Product Change Notice (PCN)

PCN Number: PCN-045-6174R-01

Product(s) Affected: PJ-040D

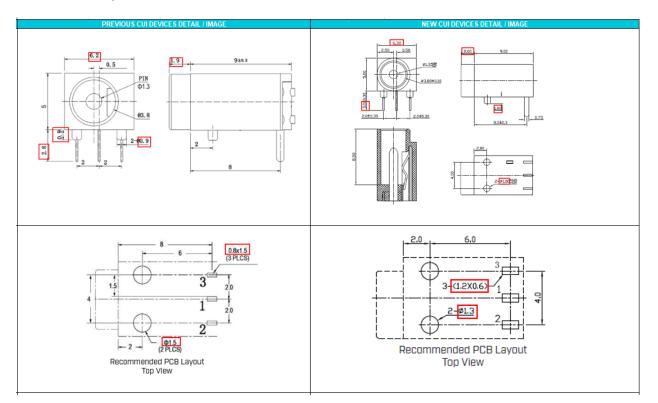
Description of Change: New Factory Location. Product re-engineered for improved manufacturability and production yield. See image below for reference and check CUI Devices website for updated drawing. Cosmetic differences may be visible and not affect the form fit and function of the product.

PREVIOUS CUI DEVICES DETAIL / IMAGE				NEW CUI DEVICES DETAIL / IMAGE			
			-				Di 17110 (00) 00
DESCRIPTION	MATERIAL	PLATING/COLOR	-		DESCRIPTION	MATERIAL	PLATING/COLOR
center pin	brass	silver	-		center pin	brass	silver
terminal 1	brass t=0.25	silver	-		terminal 1	brass t=0.25	silver
terminal 2	brass =0.25	silver	-		terminal 2	SUS301 t=0.25	silver
terminal 3	brass t=0.25	silver	-		terminal 3	brass t=0.25	silver
cover	PBT (UL94V-0) PBT (UL94V-0)	black black	_		housing	PA66 UL94V-0)	black
Ø3.5 Ø1.35 MATING PLUG Jack Insertion Depth: B.0 mm				MATING PLUG Jack Insertion Depth B.5 mm
